**BURLINGTON  
ENVIRONMENTAL**

Enclosed are four requests for variances from the Burlington Environmental Inc.  
Pier 91 RFI Workplan.

REQUEST FOR VARIANCE FROM PIER 91 RFI WORK PLAN  
March 23, 1993

REQUEST FOR VARIANCE FROM PIER 91 RFI WORK PLAN  
April 5, 1993

CONTOURS OF TOP OF  
SILTY SAND LAYER

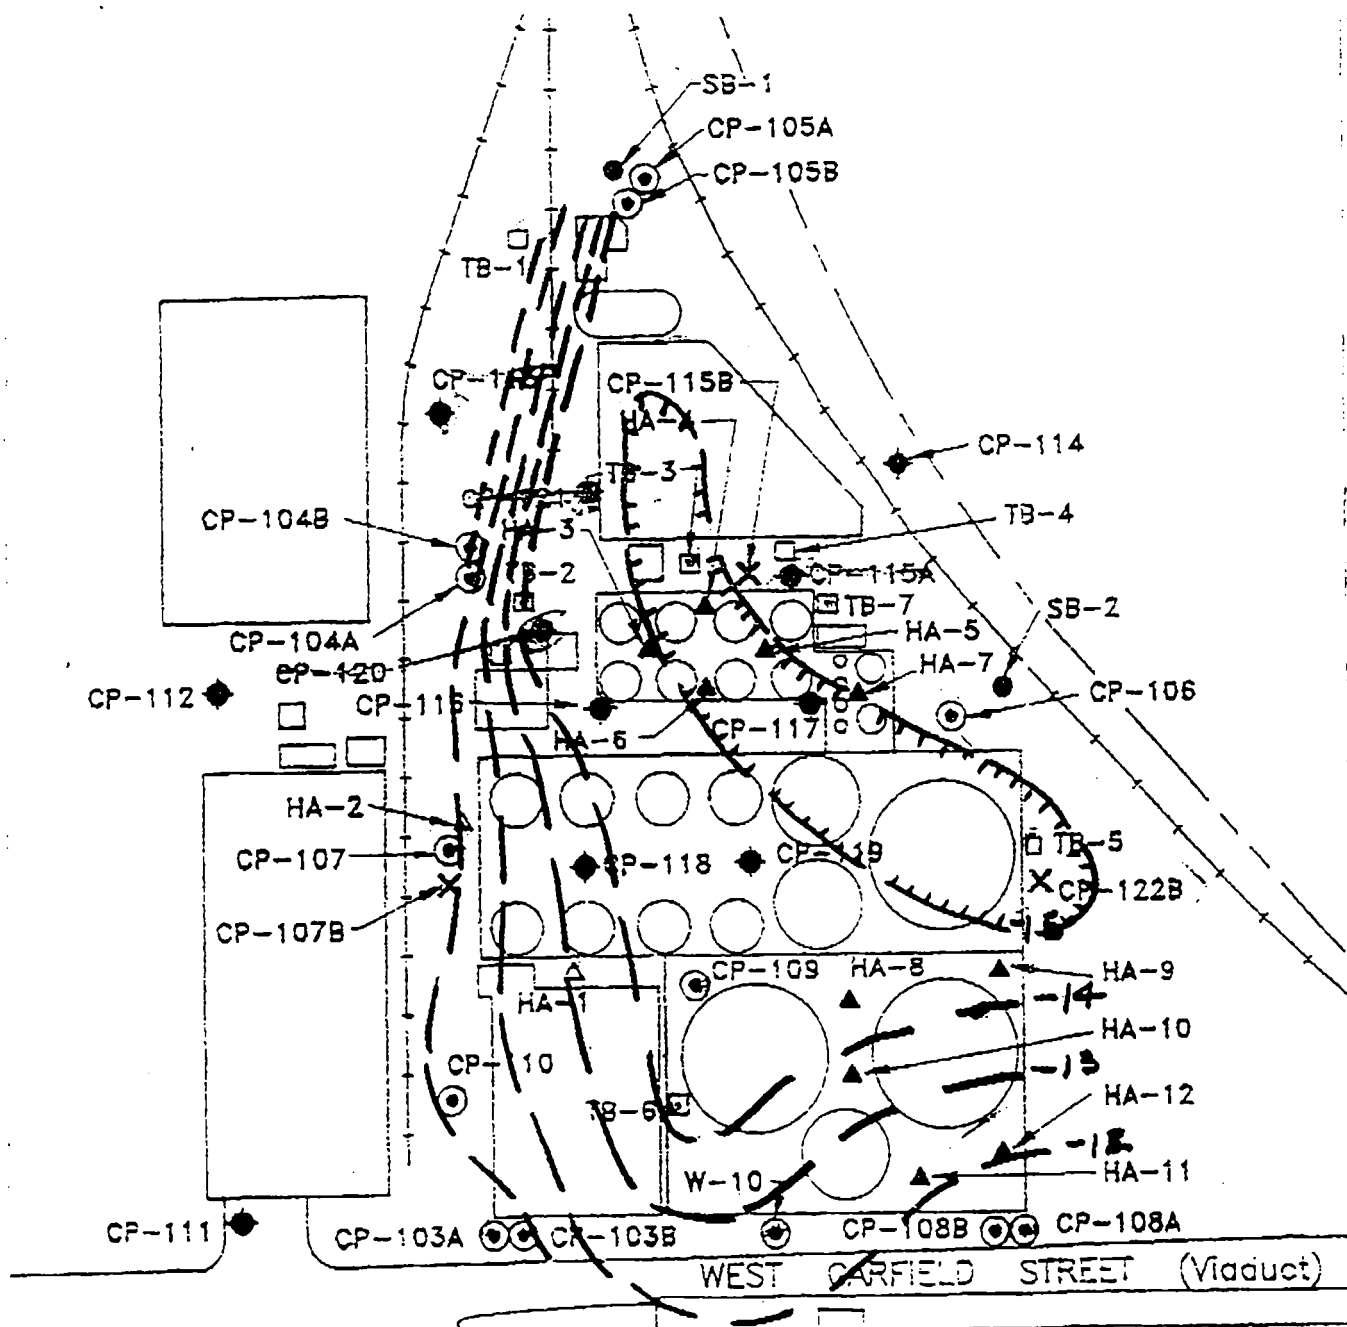
A contour map of the upper surface of the silty sand layer was prepared by the USEPA (July 1992) from limited data. The map shows a high along the western side of the property that Burlington leases from the Port of Seattle, with the surface sloping eastward. Subsurface DNAPL is not expected to accumulate on such a slope, but rather is expected to accumulate in any topographic depressions that might exist in the surface of the less permeable layer.

With respect to the inferred upper surface of the silty sand layer, well MW-39-3 is located topographically upslope of the oil/water separator. Therefore, if DNAPL has been released in the area of the separator, it is not expected to accumulate in this area. As such, a DNAPL-detection design is not required for the well.

As part of the ongoing RFI, monitoring well CP-115A was installed at a location approximately 120 feet east of the separator, in the area of the inferred topographic low in the upper surface of the silty sand layer. This well contains a DNAPL-collection sump, and therefore provides detection capability for DNAPL that may have migrated from the area of the separator.

FIGURE 1-3  
BUILDING W-39 VICINITY MAP

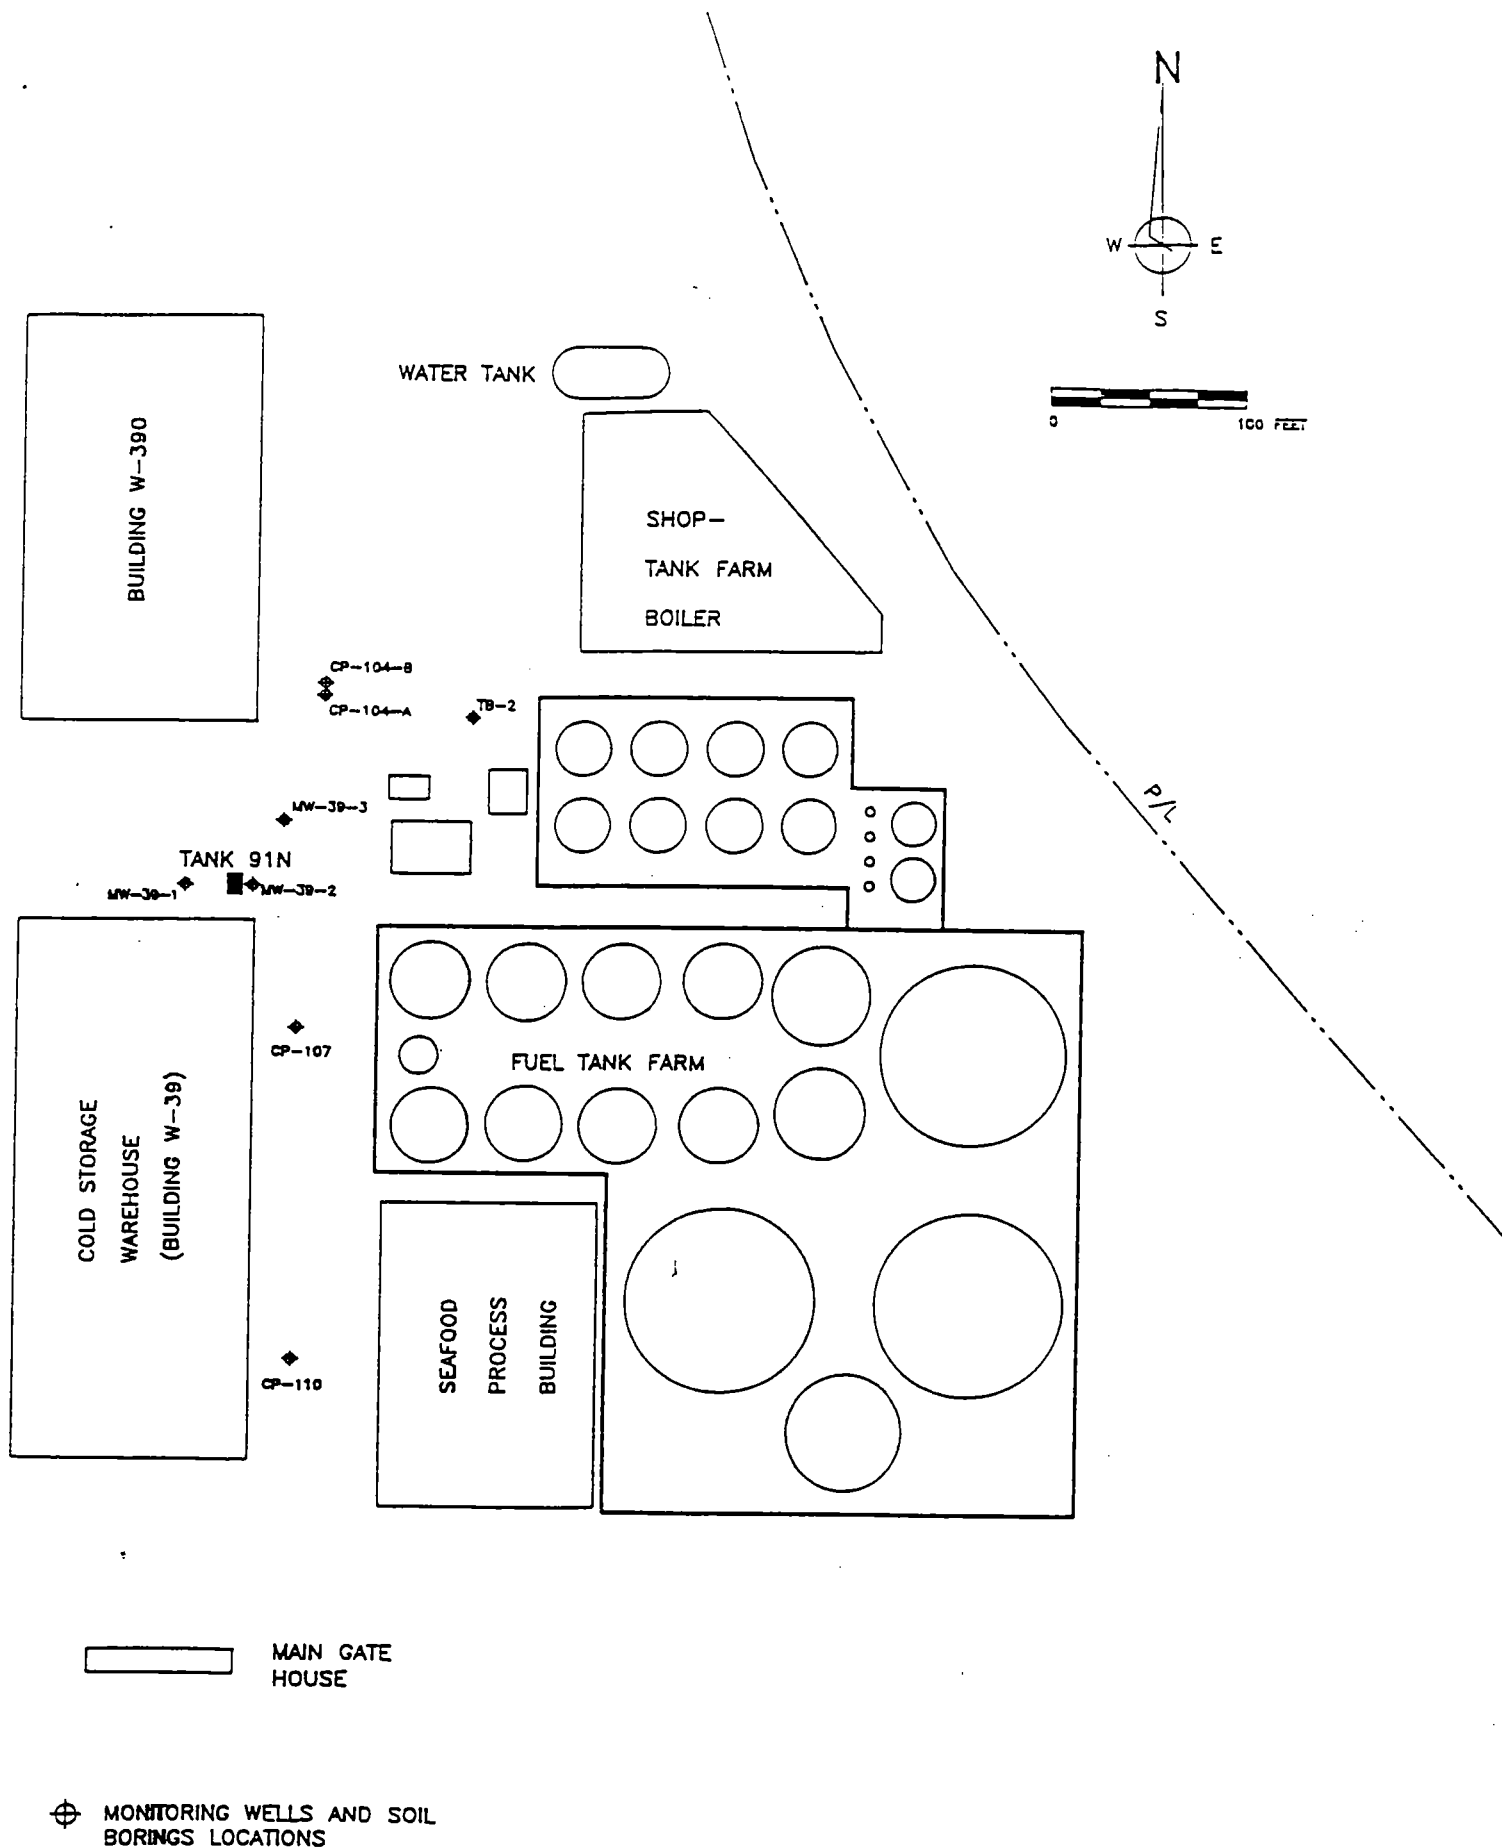
Three groundwater monitoring wells are located approximately southwest of the oil/water separator. These wells, designated MW-39-1, MW-39-2 and MW-39-3, were completed in the shallow aquifer as part of an underground storage tank (UST) investigation conducted by Harding Lawson Associates (HLA) for the Port (HLA, 1990). The attached figure, labeled "BUILDING W-39 VICINITY MAP", shows the locations of the three Port wells.

Port well MW-39-3 is located approximately downgradient (hydraulically) of the oil/water separator. Therefore, this well appears to be properly located for the detection of any contaminants that may be dissolved in groundwater migrating horizontally away from the area of the separator.

Burlington Environmental Inc. (Burlington) requests a variance from the Burlington Pier 91 RCRA Facility Investigation (RFI) Work Plan (Burlington, 1992). As part of this variance, Burlington would incorporate the Port of Seattle (Port) monitoring well MW-39-3 in Burlington's groundwater monitoring network in lieu of installing and sampling proposed well CP-120. Burlington would collect groundwater and/or product samples from Port well MW-39-3 at the same time the other wells in the network are sampled. The sample collection and analyses would be performed in accordance with the RFI Work Plan. The relevant background information and technical justification for this variance are provided below. Burlington is confident that this variance can be effected without compromising the overall goals of the RFI.

PROPOSED CONSTRUCTION DETAILS

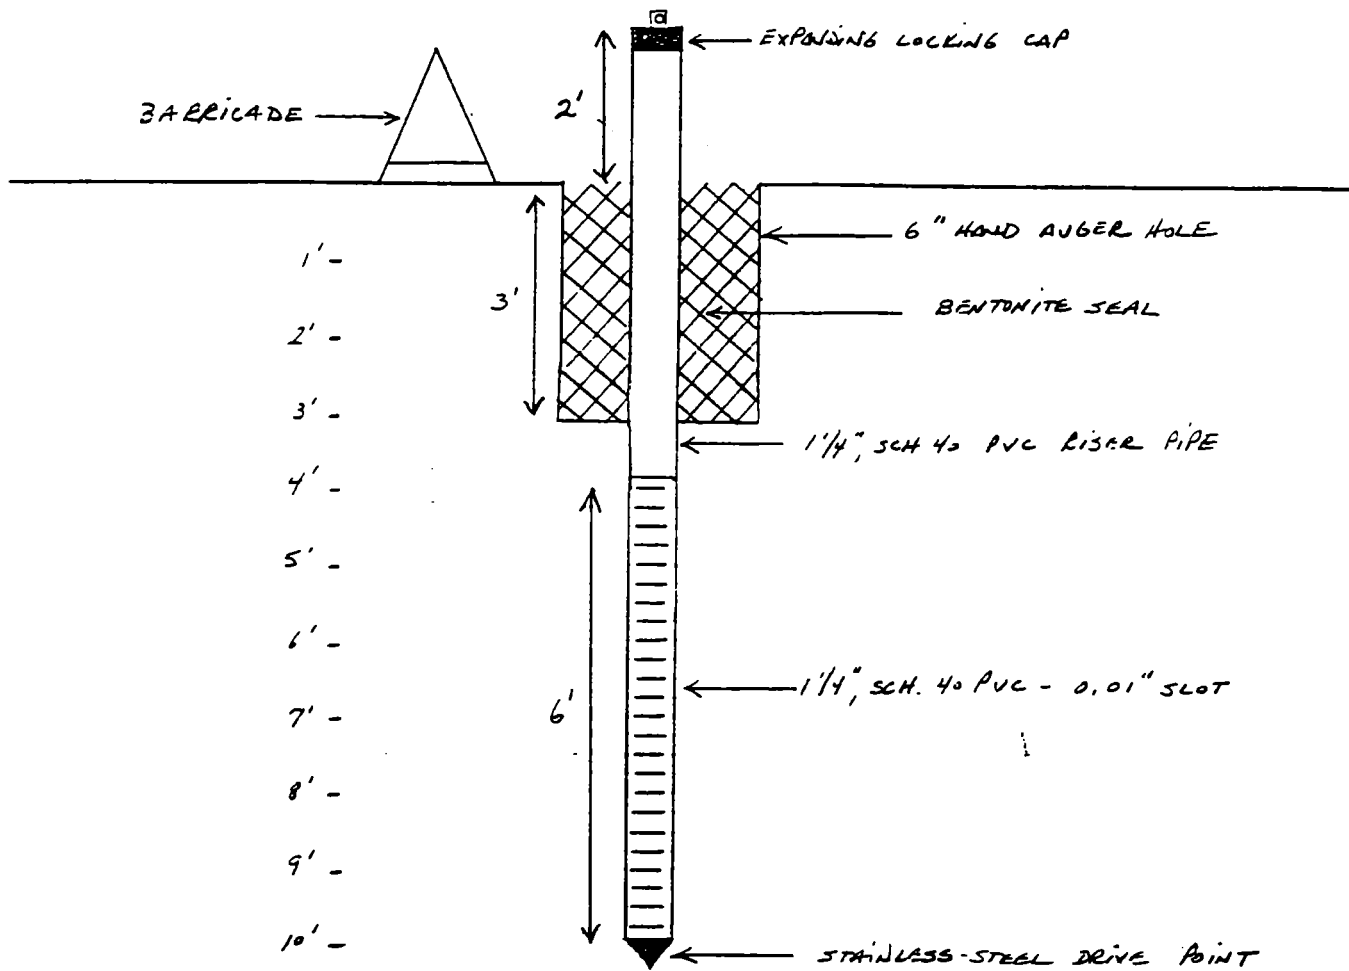
Unstable conditions were observed at the proposed well location during previous drilling attempts. These conditions include surface settlement and subsurface voids. Installation of a permanent shallow monitoring well in this area is considered impractical because the well is likely to be damaged to the extent that it is no longer capable of yielding representative groundwater samples. This could happen in two ways. First, further soil settlement could occur, causing damage to the well. Second, excavation could be required in the future to correct the unstable conditions, and this might damage the well. In addition, damage to the well could potentially compromise the surface seal.

A schematic diagram of the proposed well CP-122A is shown on the attached figure. The proposed well construction methods are consistent with all applicable State of Washington regulations regarding well construction, except for the surface protection requirements. Verbal approval for a waiver of surface protection requirements was granted to Burlington by Rod Thompson of the Washington Department of Ecology on February 24, 1993 (see attached letter).

Based on the above considerations, Burlington proposes to install CP-122A as a temporary piezometer to be used as a shallow-aquifer observation point during the pumping test. The piezometer will be abandoned after the test is completed and the piezometer location has been surveyed. This plan is consistent with the original intent of the well.

- 1) Core a hole through the surface concrete slab, at the planned location of well CP-122A. The hole will be approximately eight inches in diameter.
- 2) Bore a six-inch-diameter hole to three feet below ground surface (bgs) using a hand auger.
- 3) Place a temporary six-inch-diameter polyvinyl chloride (PVC) pipe in the borehole. This pipe will serve as a protective casing to prevent the borehole from caving during well installation.
- 4) Drive a 1.25-inch outside-diameter, Schedule-40 PVC well to approximately ten feet bgs. The well will consist of six feet of 0.01-inch slotted PVC and a stainless steel drive point, with six feet of 1.25-inch outside-diameter PVC riser pipe.

- 5) Remove the protective casing from the borehole while filling the annulus, with bentonite chips, to approximately eight inches bgs (the depth of the bottom of the surface concrete in the area). Hydrate the bentonite chips.
- 6) Following hydration of the bentonite chips, allow the well to rest undisturbed for a minimum of two hours. Then, develop the well using some combination of the following: bailer, peristaltic pump, surge block.
- 7) Install an expanding locking cap in the upper end of the riser pipe. A padlock will be installed on the cap, and will be kept locked at all times except when the well is being used to monitor water levels.
- 8) Place temporary barricades around the well to protect the riser pipe from damage by motor vehicles and pedestrians.
